Interactive comment on “Mobile-Platform Measurement of Air Pollutant Concentrations in California: Performance Assessment, Statistical Methods for Evaluating Spatial Variations, and Spatial Representativeness” by Paul A. Solomon et al.

Anonymous Referee #3

Fig. 1.

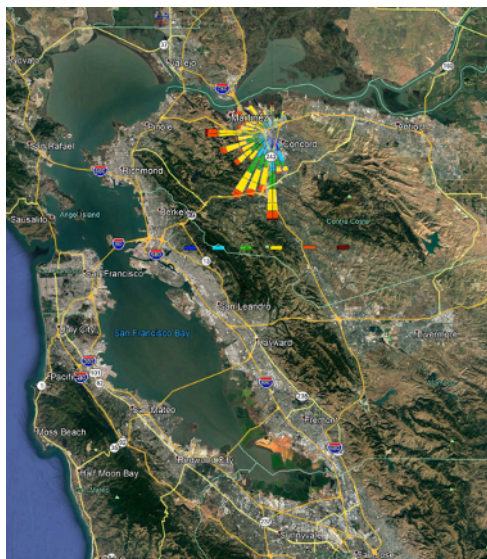
data between 1973-2019 at Buchanan Field Airport in Concord, CA. Figure 1 shows the month of March may be experiencing inflow from the Chevron processing plant in Richmond and dust (Coarse mode, not reported) from Dutra Materials quarry in McNeers Beach, while to a much lesser extent in November (Figure 2). Since the data is presented as mean concentrations during the sampling periods, I'd bet the baseline PN concentrations are different for the two months. Lines 251-252: The deployed optical particle counter provided five size ranges why report only the smallest, then reference a paper regarding a measured size bin that was not reported in the paper? Lines 246-262: I'm not sure this section is representative and should be included here and should likely be absorbed by the following sections. Line 265: Typo. ...vehicles drove in the Los Angeles Line 270: Why was the mean relative difference between the two calibrations so high? An absolute difference of 5% NPAP would require corrective actions. The calibration gases and flow meters used should be traceable to NIST for re-evaluation. Sec. 3.2: When comparing inter-vehicle observations were the vehicles traveling the same route (i.e. following each other) or just driving the same neighborhoods and passing by each other? Line 294: Were the vehicles were running during the LAXH comparison or were the instruments moved to shelter power and the vehicle engines shutoff? Sec. 3.3: Last sentence of section, CH₄ emissions from vehicles is extremely small (something like <0.2% of anthropogenic emissions) and the lifetime of NO very short. This statement needs a citation, or it needs to be removed. Sec 3.4: This section will have a very large dependence on meteorological parameters. Sec. 3.4.1: The airmasses the vehicles are sampling are potentially different. An intervehicle comparison could be made in time and latitude. As it is, the comparisons are meaningless because we know the location of any vehicle at any given time and one may be sampling south of the Santa Ana Freeway and the other sampling all three major N-S freeways in the area. The attached Figure 3 shows winds are between 9am and 5pm averaged over Aug 3-16. Line 362: Driving near as in right past along Dowlen Dr or within n meters? Wilshire Blvd is ~200m as is Federal Ave. Line 392: What grid is used? Fig. 6: Needs legend, different colors for positive and negative intervehicle
